**IN THE DRAWINGS:**

FIG. 2

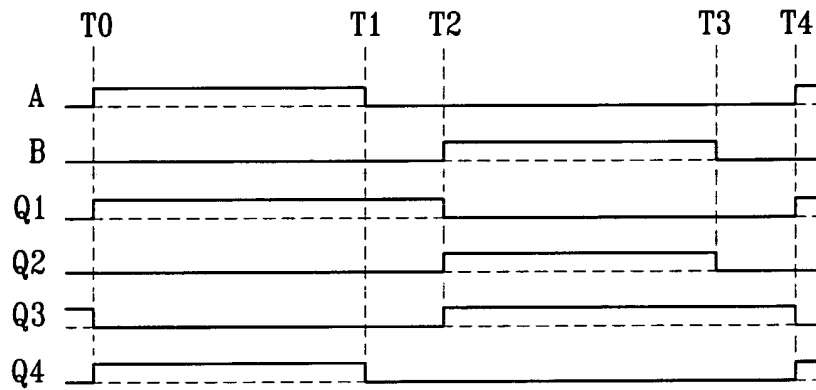
Applicants include a correction to FIGURE 2. The waveform Q3 in FIG. 2, prior to time T0, is amended to illustrate as high state. Support for this amendment to FIG.2 can be found in the present Application, among other places, on page 6, lines 1-3. Applicants introduce no new matter through this correction.
